Product Change Notice

Change Type:Add ASE-KH as a 2nd source wafer sort (i.e. wafer probe) site**Parts Affected:**

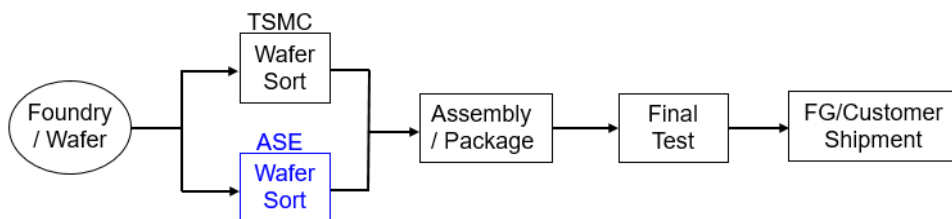
Electrical wafer sort testing is currently performed on this product at TSMC Fab 14 (Tainan, Taiwan R.O.C.). Broadcom will add ASE-KH (Kaohsiung City, Taiwan R.O.C.) as a 2nd source for wafer sort. There is no change to Foundry, Assembly or Final Test – see updated flow below.
